**43 Barkley Circle, Suite 200
Fort Myers, FL 33907
Phone 239-433-4231 Fax 239-433-9632
www.tdmcivilengineering.com
Certificate of Authorization # 29086**

**Reference: Williams Avenue CPD
DCI2021-00014 (1st Resubmittal)**

Zoning Section Comments:

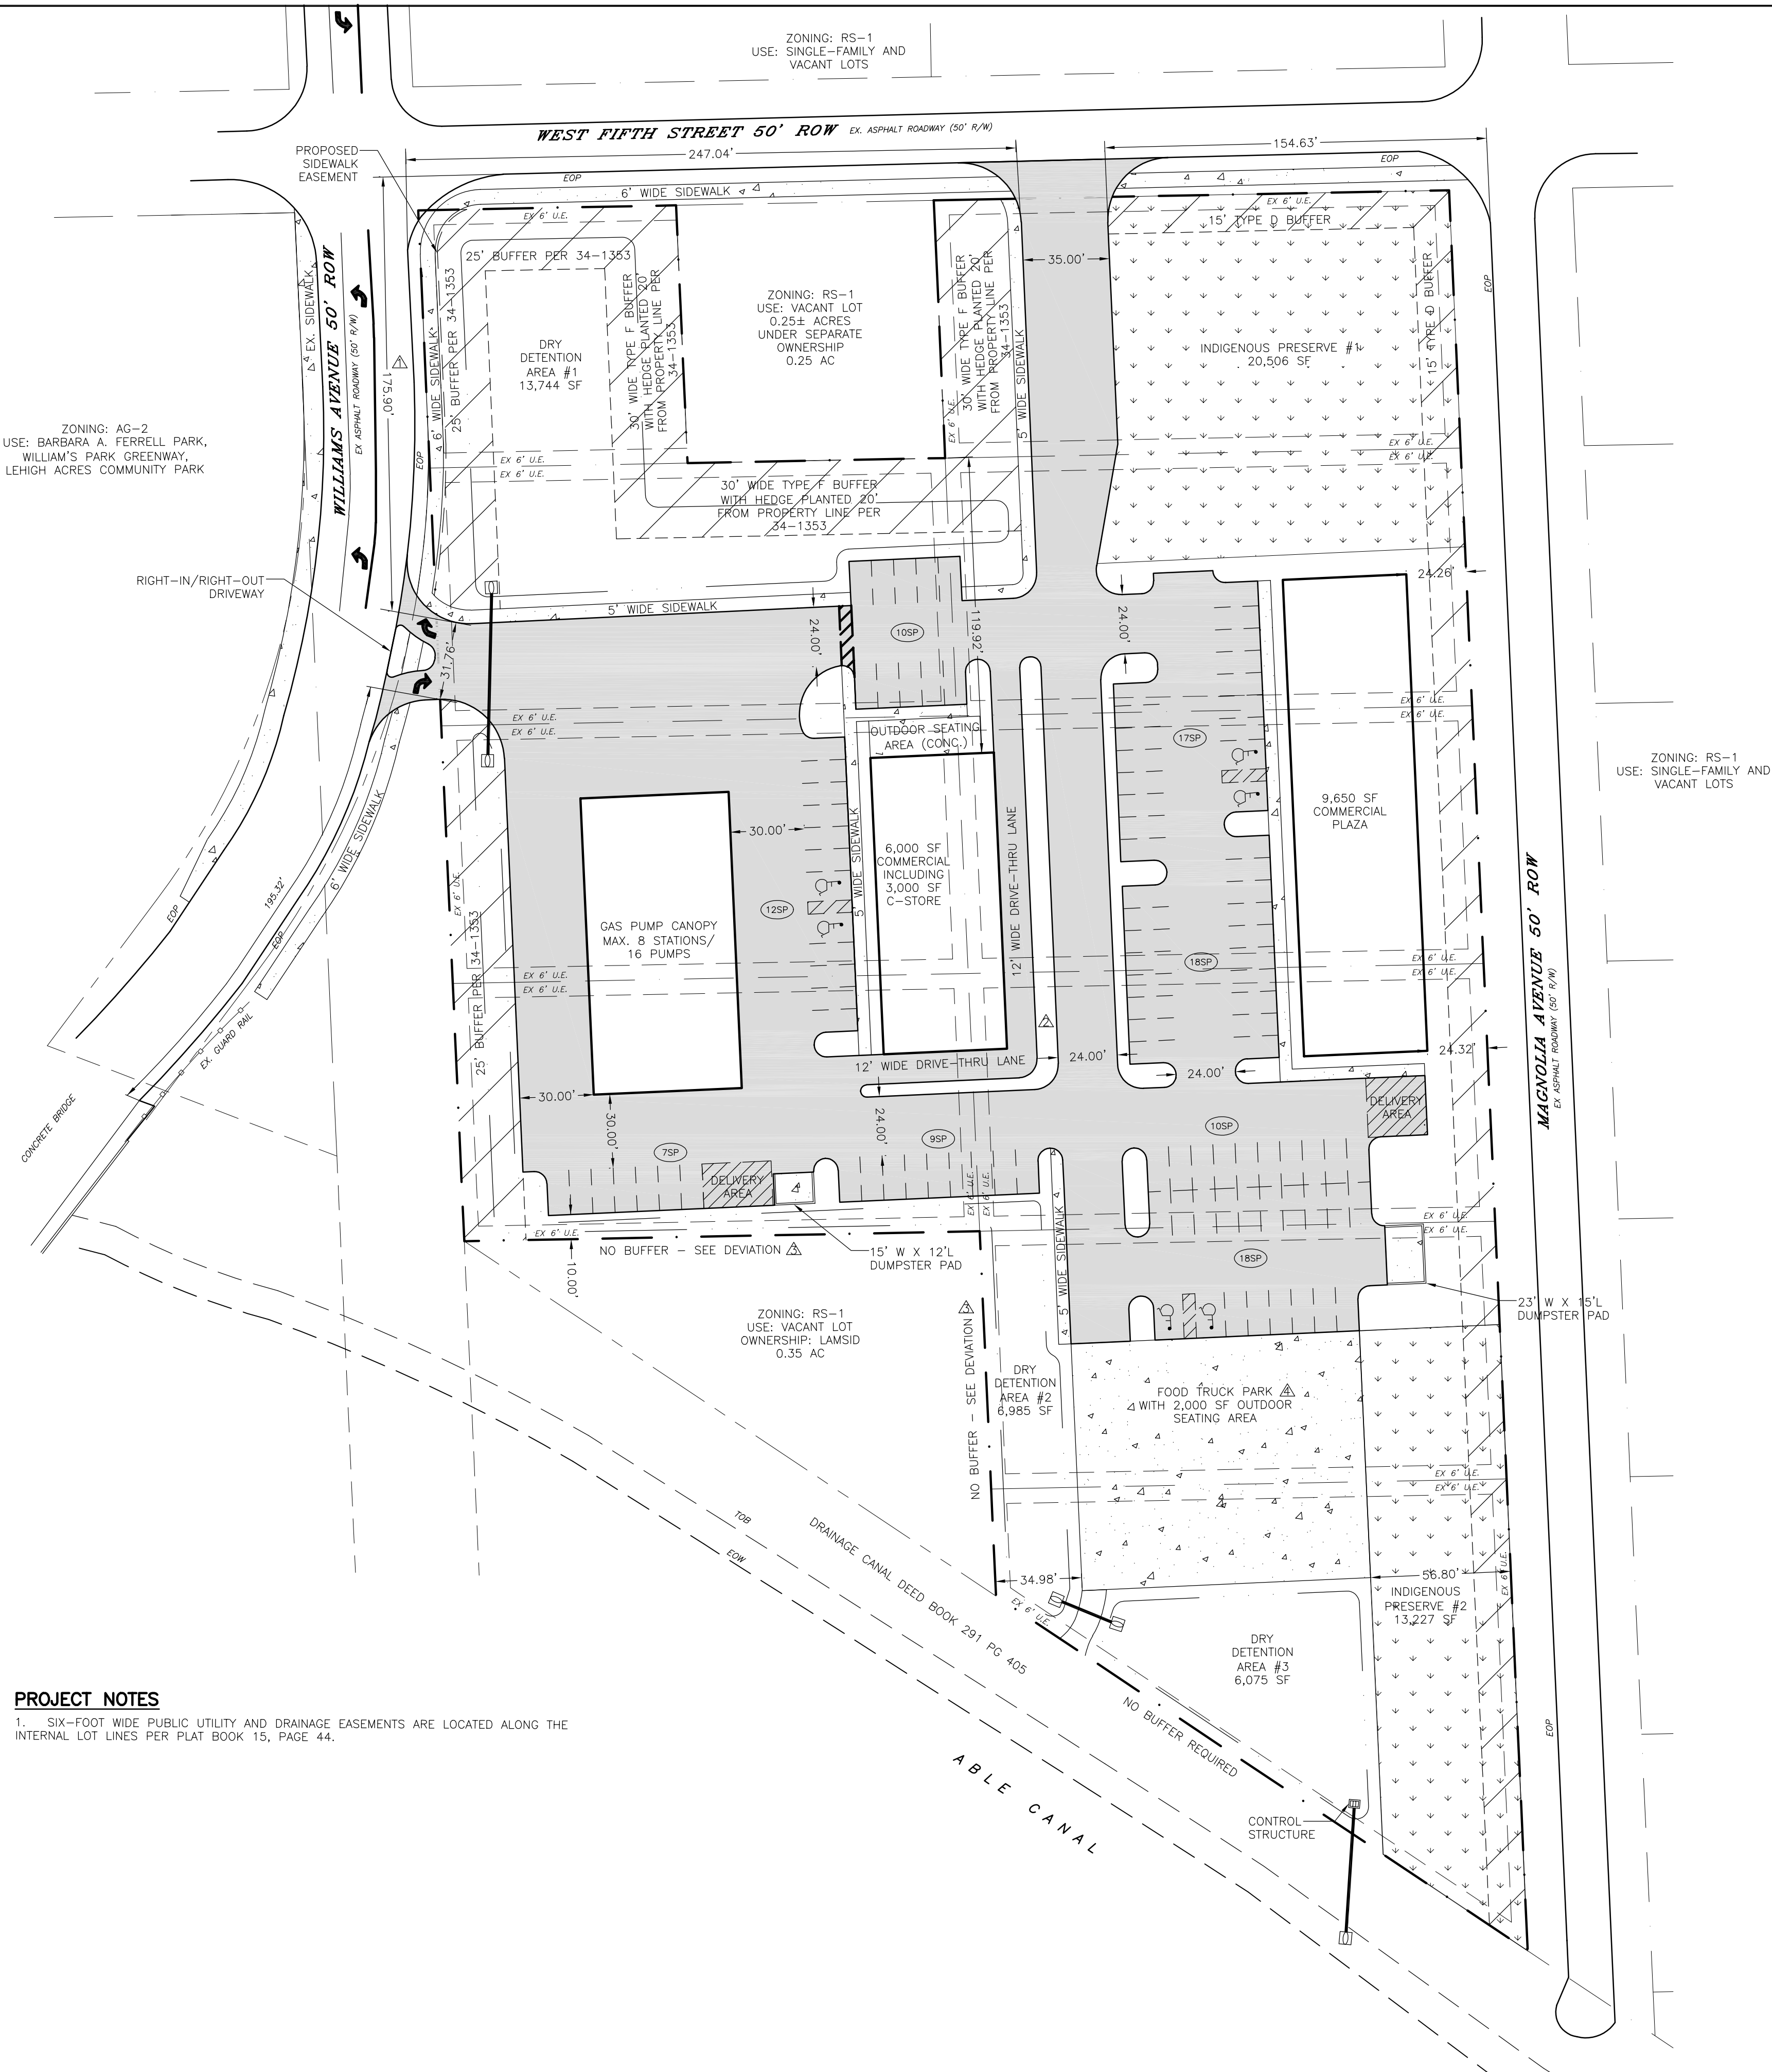
2. Master Concept Plan (MCP) – LDC Sec. 34-373(a)(6). Revise the MCP to depict:

- d. The MCP depicts an outdoor seating area, please assess the total outdoor seating area, assuming it's intended for the restaurant use. Revise the parking calculations accordingly.

Response: See the revised parking calculations on the MCP for the outdoor seating area as requested.
